FAA Implementation of ACR Recommendation 3

Return CAATT Waypoint to Pre-Metroplex location

July 2024

CHSLY SIX ARRIVAL (RNAV)

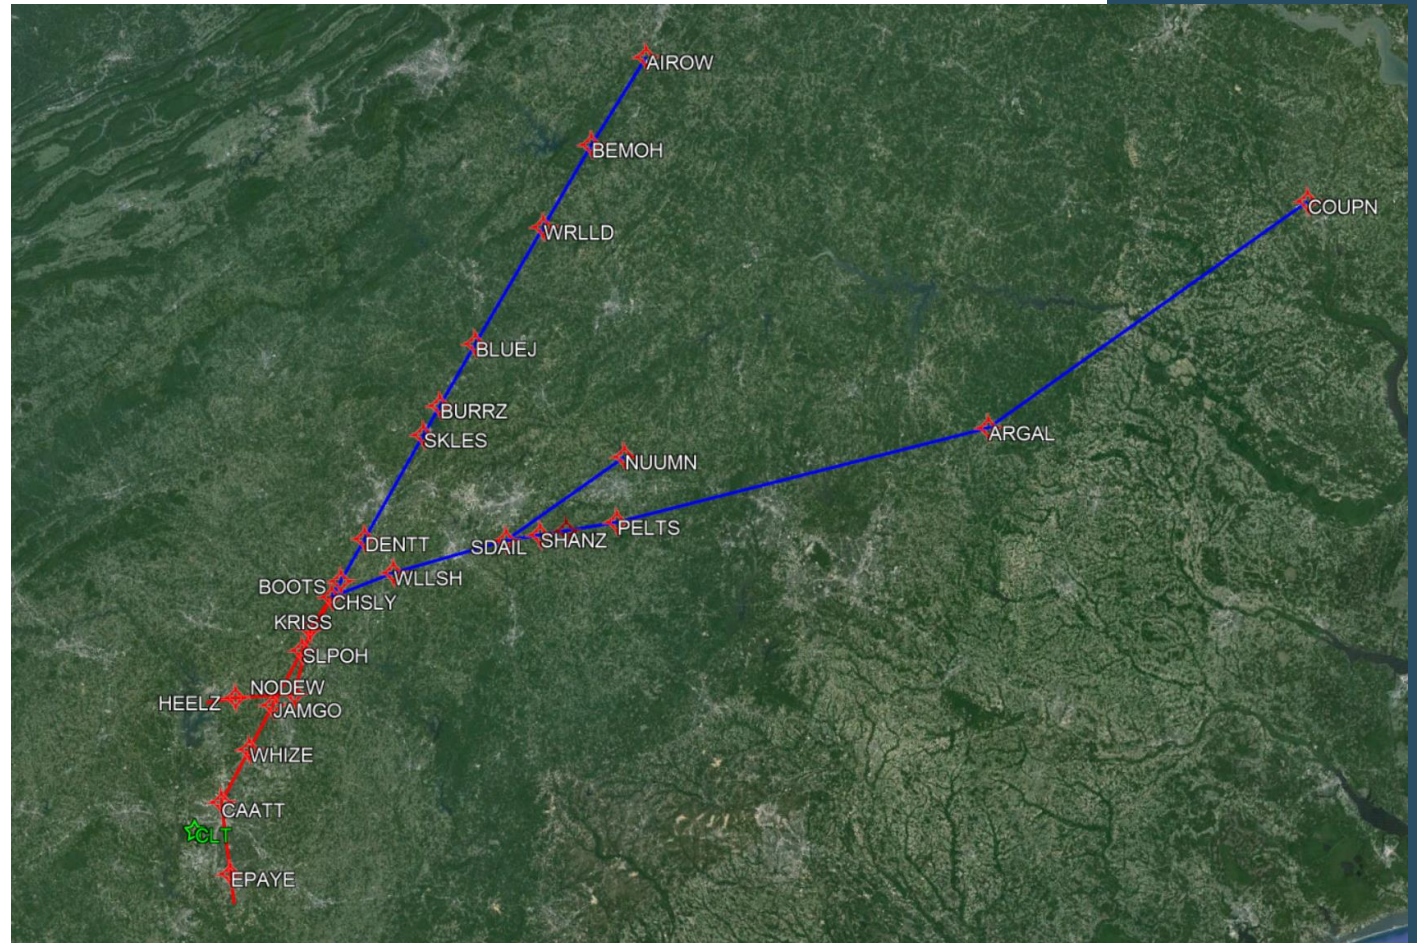
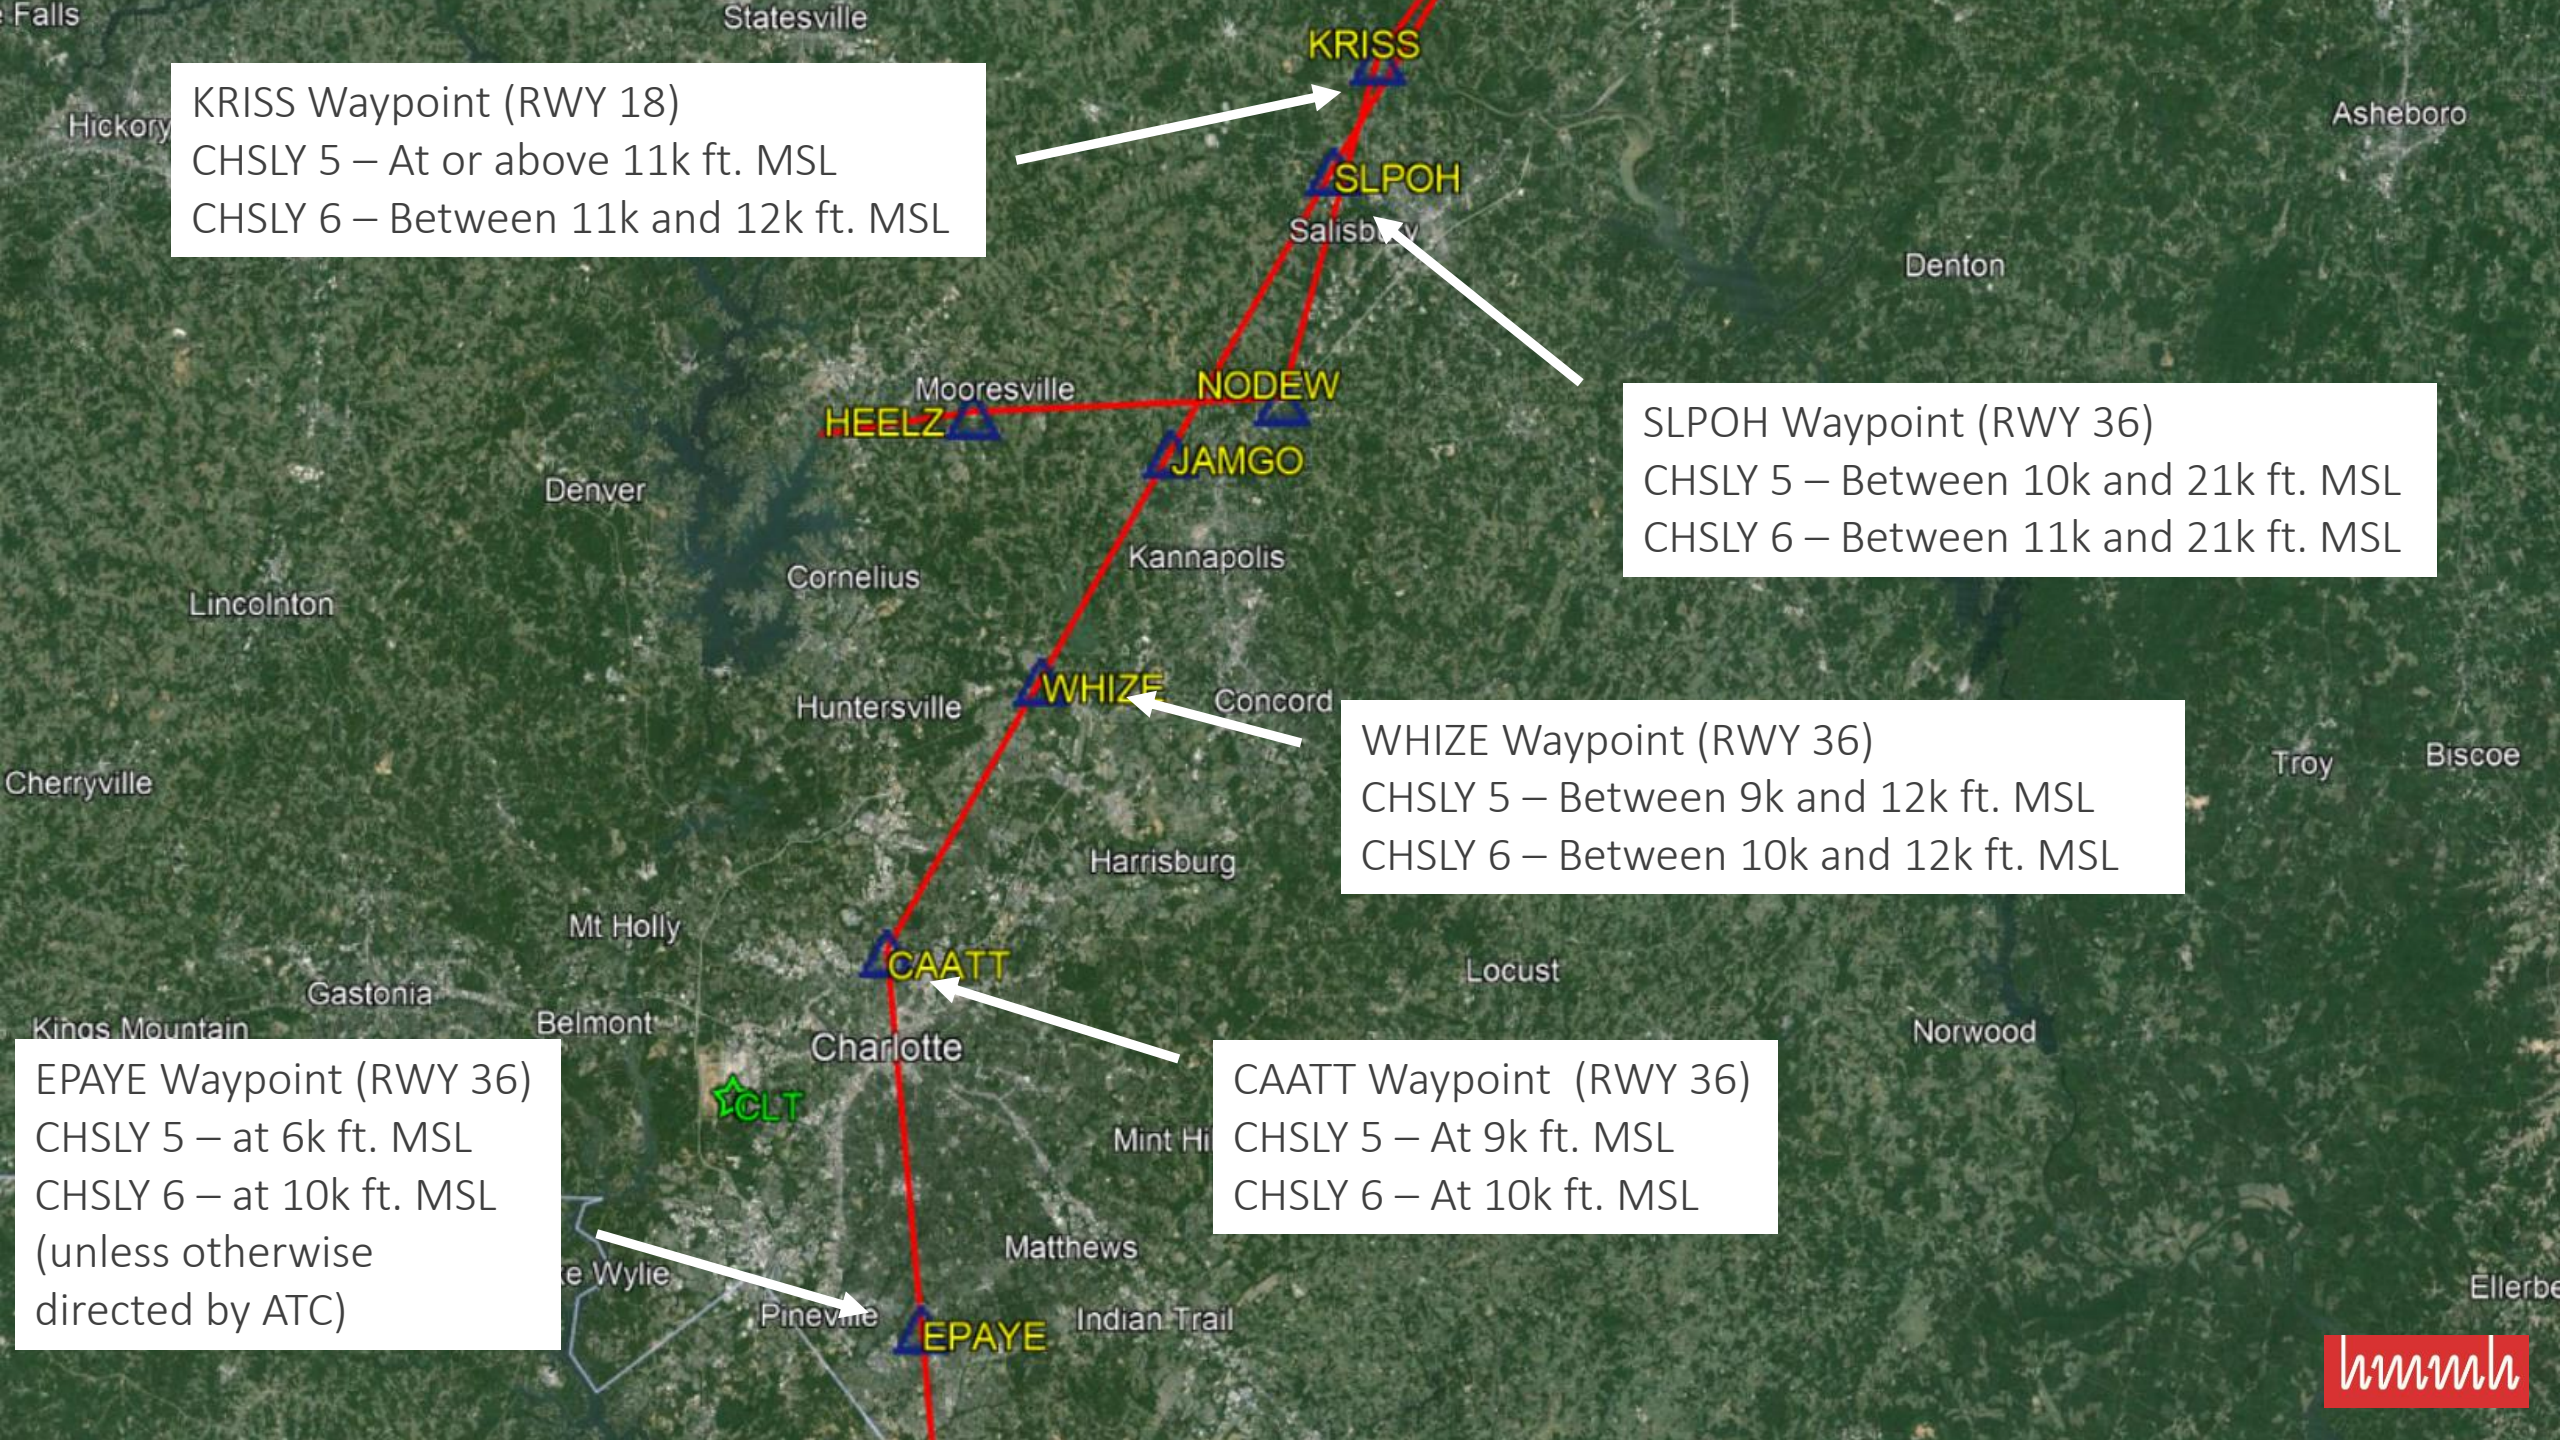
- Altitude changes:
 - SLPOH – raised lower limit of altitude restriction from 10k to 11k ft. MSL
 - WHIZE – raised lower limit of altitude restriction from 9k to 10k ft. MSL
 - KRISS – changed altitude restriction from at or above 11k ft. MSL to between 11k and 12k ft. MSL. *Lower limit remains the same
 - CAATT – raised altitude restriction from 9k to 10k ft. MSL
 - EPAYE – removed altitude restriction of 6k ft. MSL

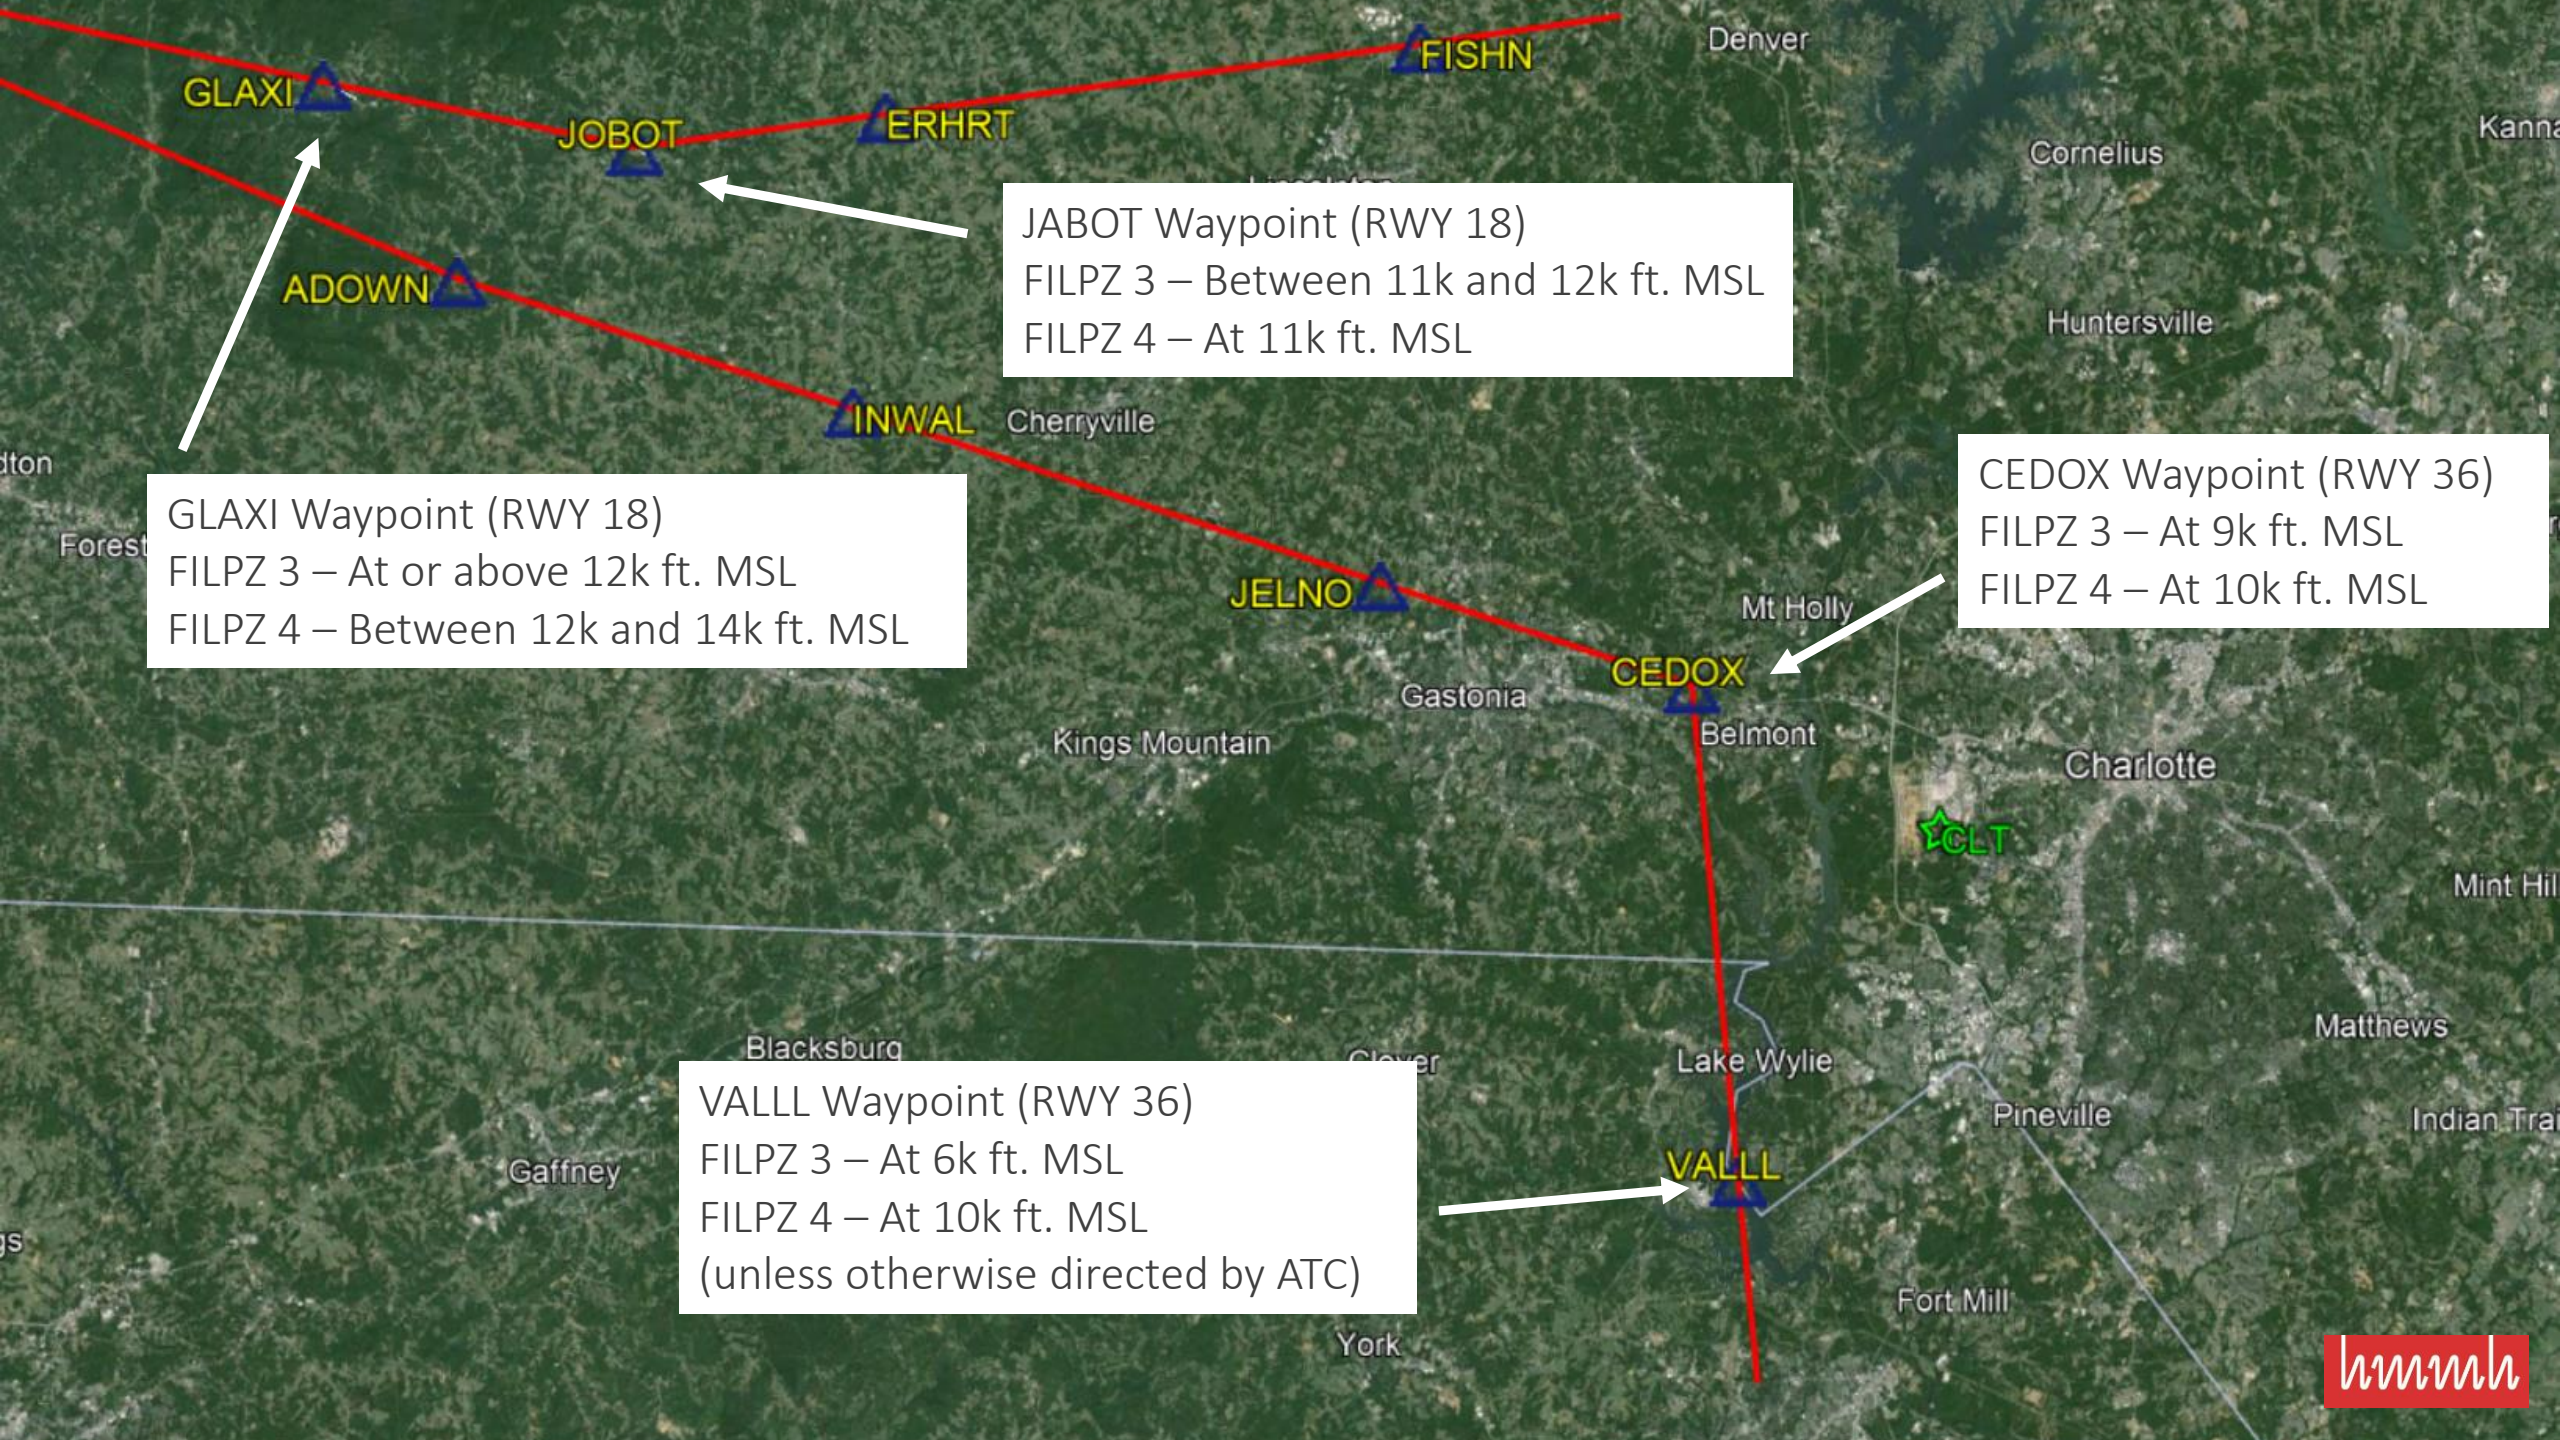
CAATT Waypoint (RWY 36)
CHSLY 5 – At 9k ft. MSL
CHSLY 6 – At 10k ft. MSL

EPAYE Waypoint (RWY 36)
CHSLY 5 – at 6k ft. MSL
CHSLY 6 – at 10k ft. MSL
(unless otherwise directed by ATC)
